Czech Sport Aircraft a.s.	<h1>SERVICE BULLETIN</h1>	Czech Sport Aircraft a.s. Na Záhonech 1177/212, 686 04 Kunovice Czech Republic office@czechsportaircraft.com
No. SB-SC-027		Rev.: -
Date: 2015-03-04		
Page: 1 of 6		Date: -

<b>MODEL AFFECTED:</b>	SportCruiser / PiperSport
<b>SUBJECT:</b>	Installation of spacers in the wing position light system, installation of the tail position light.
<b>AIRCRAFT AFFECTED:</b>	09SC285, 09SC290, 09SC294, 09SC296, 10SC297, 09SC298, 09SC302, 09SC303, 09SC305, 09SC308, 09SC321, 09SC322, 09SC323, 09SC324, 09SC326, 09SC327, 09SC329, P1001040, P1001041, P1001042, P1001043, P1001061, P1001087,

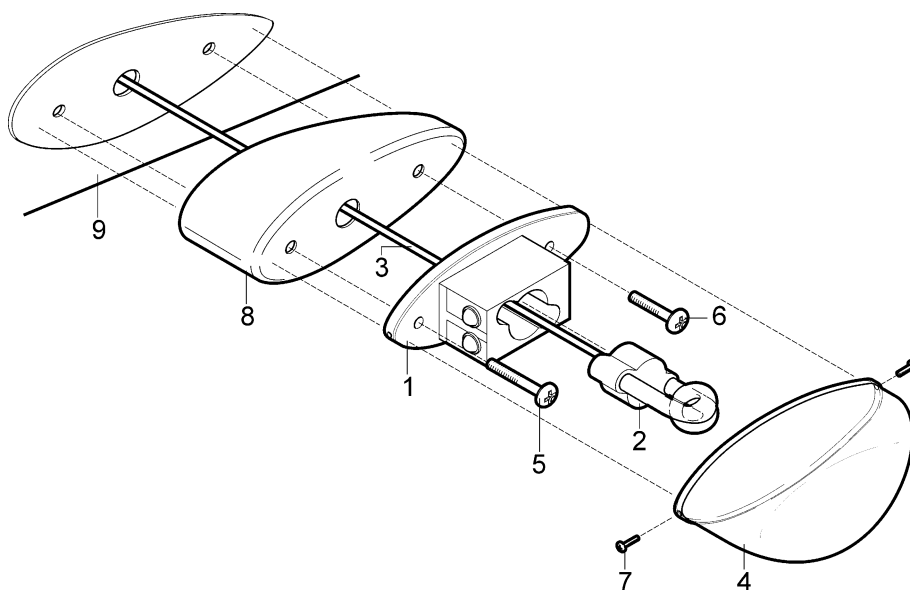
- Move the aircraft to a place suitable to perform the work.
- Remove engine cowlings, disconnect positive battery terminal (see AMM, Chapter 11).
- Remove the position / strobe lights according instructions in the AMM, Chapter 11.3.4.1,
- Install spacer between the wing tip and strobe / position light and install the position / strobe lights according instructions in the AMM, Chapter 11.3.5.1; use new self-tapping screws acc. to the figure.

| 1. Position / strobe light housing | 6. Self-tapping screw 3.9 x 32 |
| 2. Discharge tube                  | 7. Screw                       |
| 3. Wires                           | 8. Spacer                      |
| 4. Cover glass                     | 9. Wing tip                    |
| 5. Self-tapping screw 3.9 x 45     |                                |

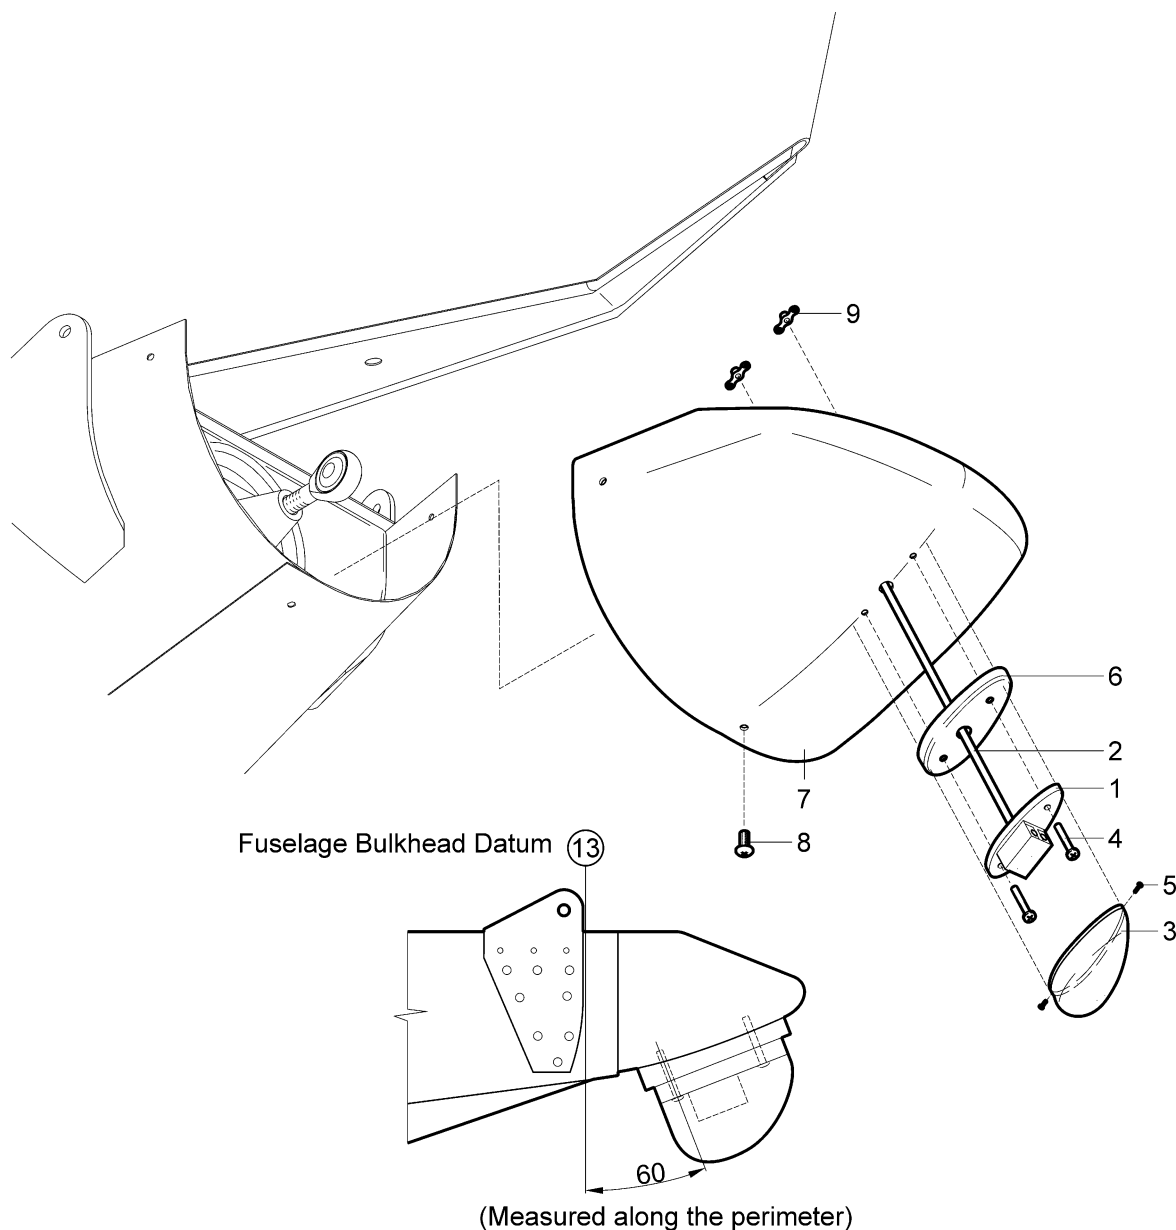
- Mark the holes for screws and wiring on the rear cover (8) as per figure.
- Remove the bolts (8) and rear cover (7).
- Drill screw holes (2 x Ø4.5 mm) in the rear cover; drill hole (Ø10 mm) for wiring.
- Place anchor nuts (9) to the rear cover, mark rivet holes.
- Drill rivet holes (4 x Ø2.5 mm).
- Rivet the anchor nuts (9) and rear cover (7) together.

1. Position light housing
2. Wires
3. Cover glass
4. Screw
5. Screw

6. Spacer
7. Rear cover
8. Bolt
9. Anchor nut

8. Connect the position lights wires (2).
9. Set the position light housing (1) and spacer (6) to the rear cover (7) and fasten it with screws (4).
10. Set the cover glass (3) to the light housing (1) and fasten it with screws (5).

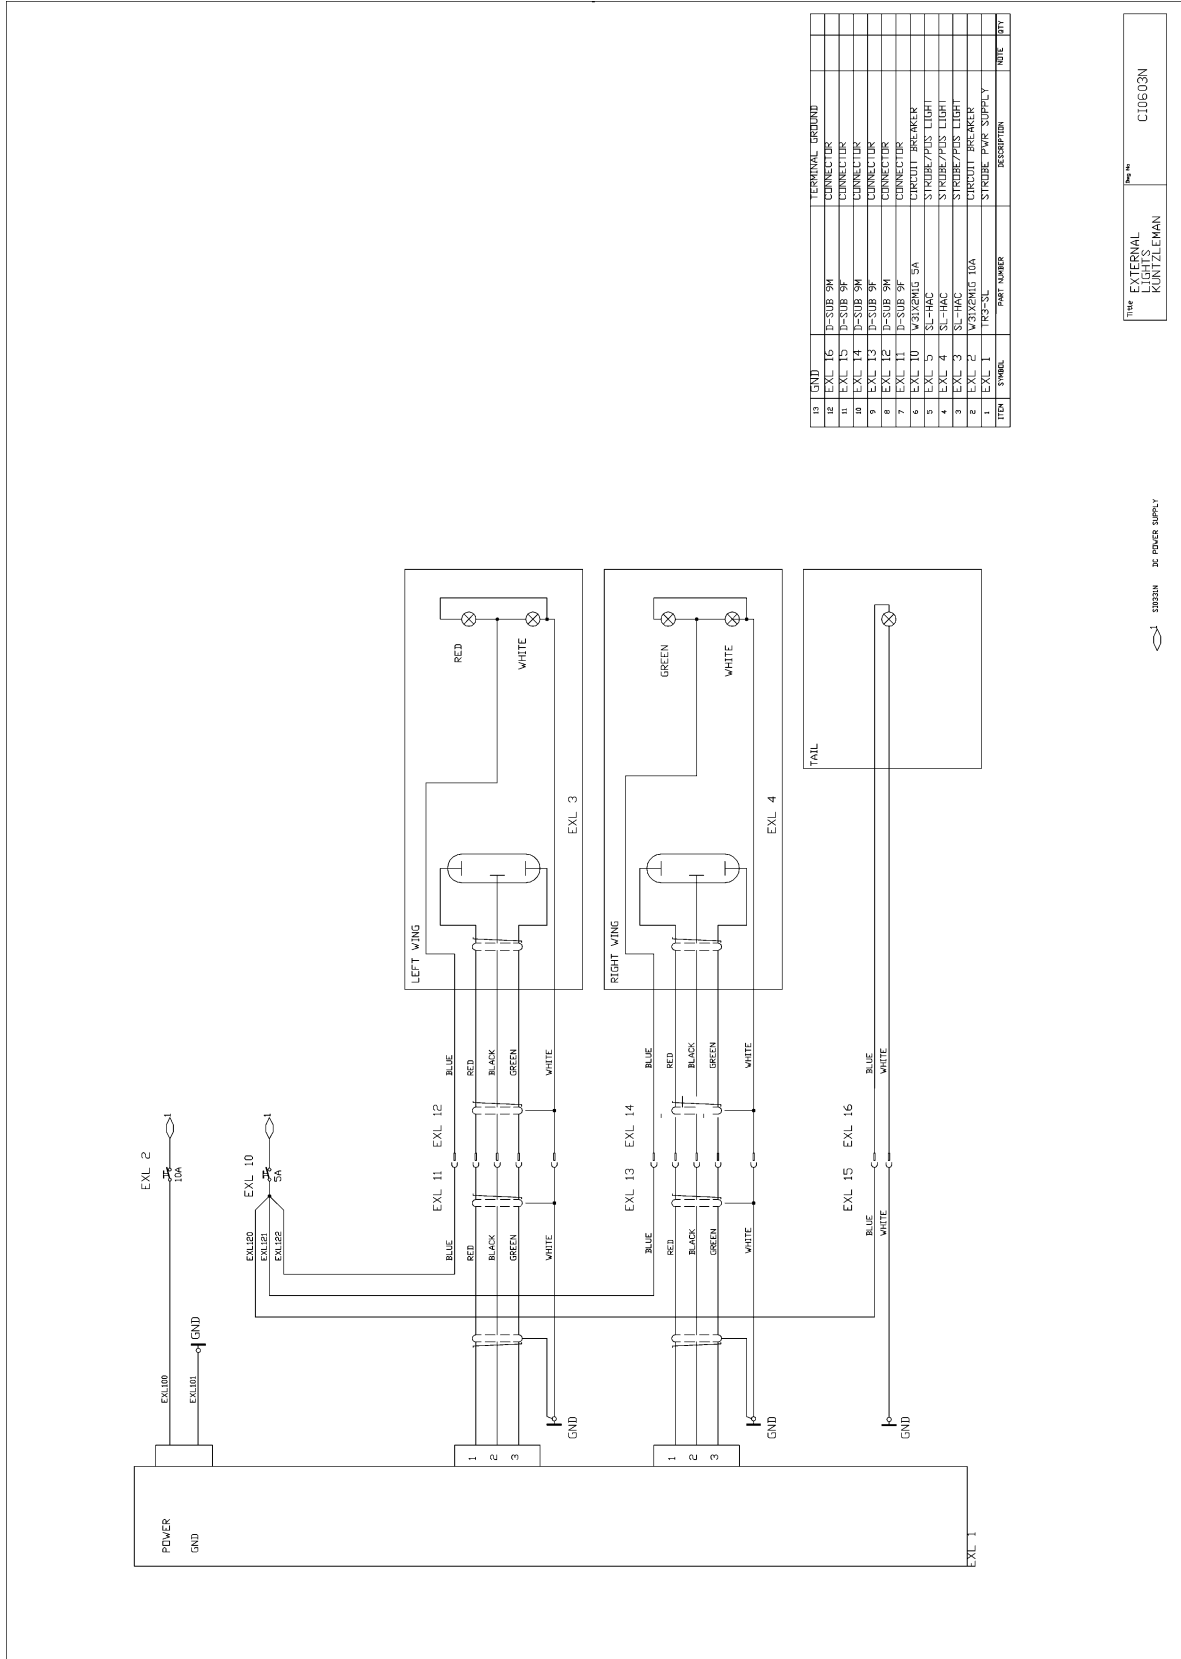
F. Connect the tail position light according to the following wiring diagram, wires appropriate manner secure.
